**From:** TFAG.PeterBoros <TFAG.PeterBoros@BTinternet.com>  
**Sent:** 10 February 2021 16:58  
**To:** 'Bowerman, Emma'  
**Cc:** 'Clerk'  
**Subject:** Objections to P20/S2808/DIS  
**Attachments:** 2020s1712 - Thames Farm, Shiplake - Hydrogeological review FINAL.pdf

| Contract            | Review of Drainage Strategy for Thames Farm, Shiplake |
| Subject             | Hydrogeological review of drainage proposal           |

**Figure 4-1 - Site footprint in relation to groundwater abstraction borehole SPZ**

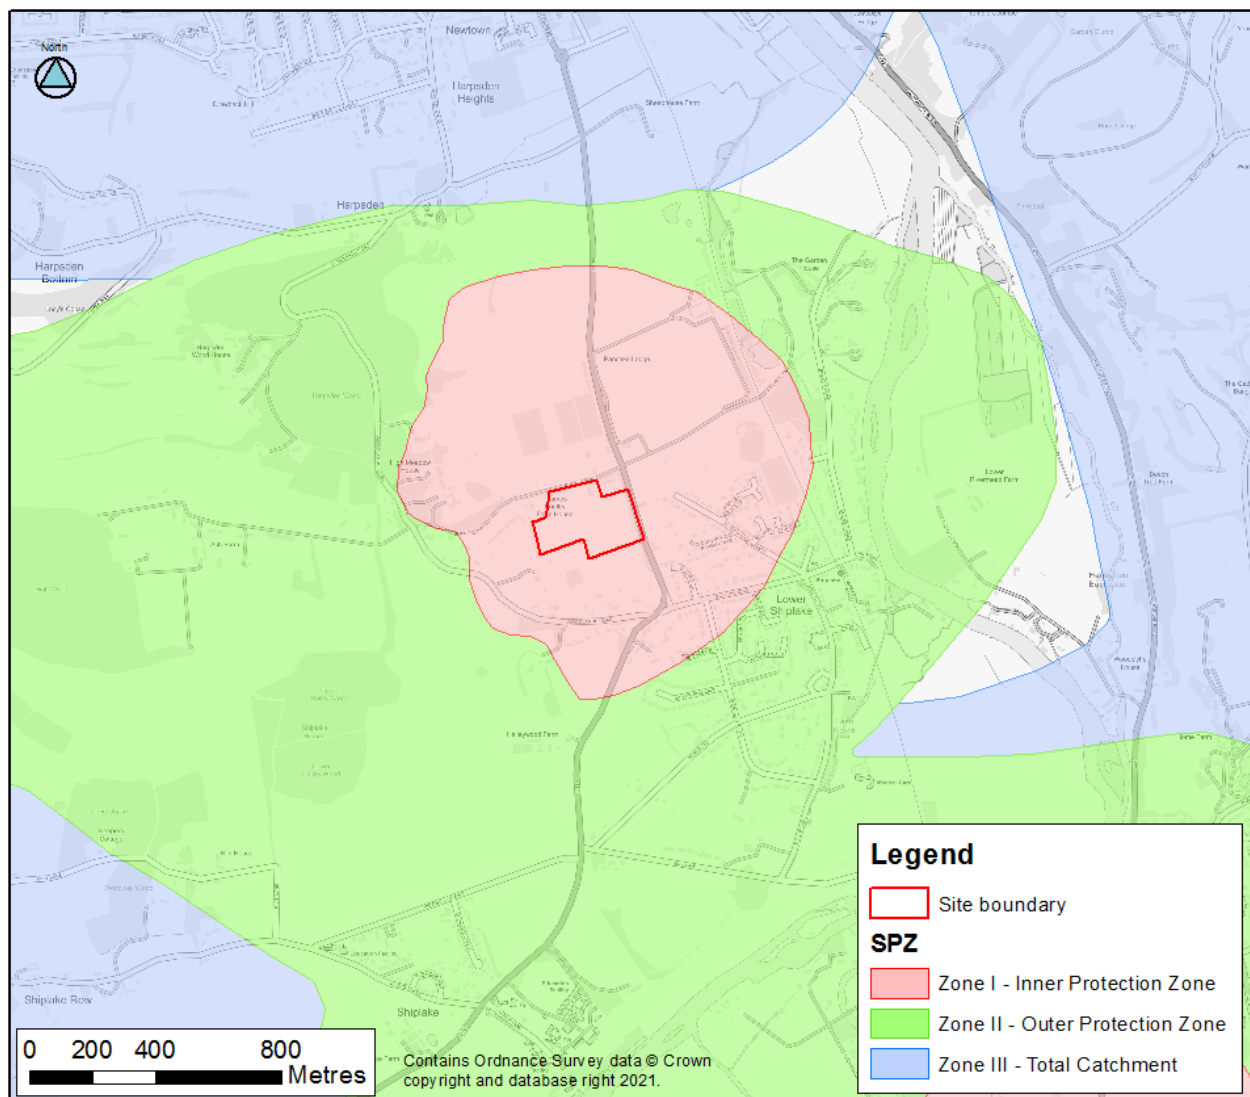
It is noted that the report does not use the most up to date SPZ mapping (see latest SPZ outlines in Figure 4-1).

The catchment required to support the borehole will increase due to this loss of infiltration across the site, which is sited in the SPZ 1 for the Thames Water PWS. This will mean a larger area would be within the 50-day travel time covered by the SPZ 1. The SPZ 1 would need to be redrawn, bringing new areas into SPZ 1. This would have two potential impacts:

- Increase the likelihood of the borehole being affected by pollution incidents,
- Put new SPZ 1 restrictions on the uses of parcels of land formally not subject to them, reducing their potential utility. This also relates to Policy ENV12 detailed above, which states that there should not be significant adverse impacts on the amenity of neighbouring uses. The SPZ 1 area is approximately 1,280,000 m<sup>2</sup> while the site footprint is 57,300 m<sup>2</sup> (see Figure 4-1), which is approximately 4.5% of the SPZ 1 area.
